FINAL
SOIL SAMPLING RESULTS AND PRELIMINARY RISK ASSESSMENT
FOR THE NORTH RIDGE ESTATES SITE
KLAMATH FALLS, OREGON

D. Wayne Berman, Ph.D.
Aeolus, Inc.
751 Taft St.
Albany, CA 94706

September 28, 2004

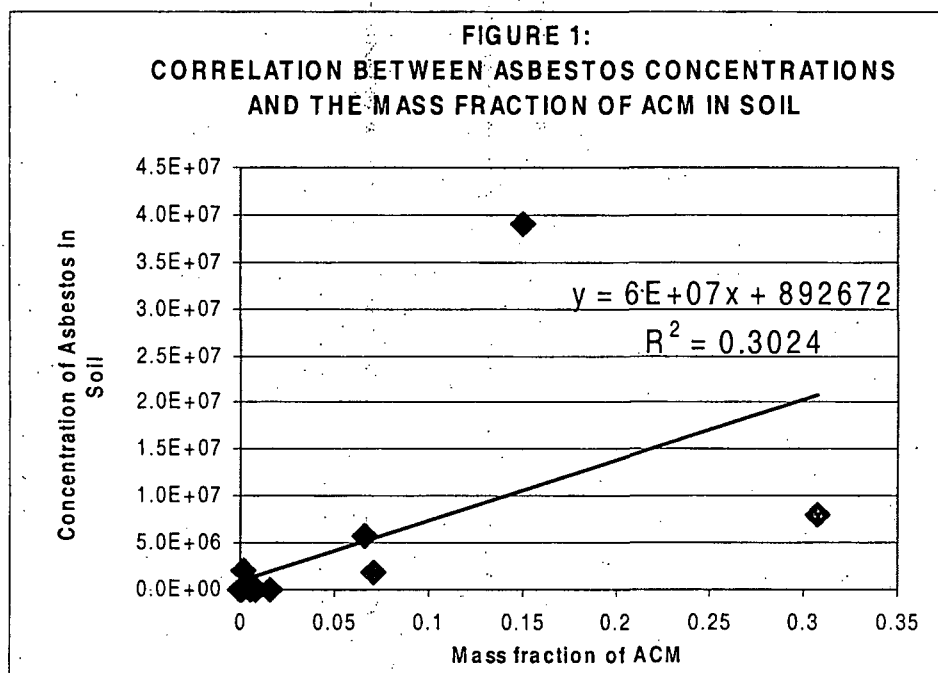
to answer Karen's question

The second effect that historical cleaning may have on the relationship depicted in Figure 1 would be to increase the variability of the observed values around the idealized relationship. Thus, if we had been able to sample "undisturbed" material (i.e. where cleanup had never been conducted), the correlation coefficient for the relationship might be higher than that currently observed. Nevertheless, as indicated above, the relationship that is observed is still statistically significant.
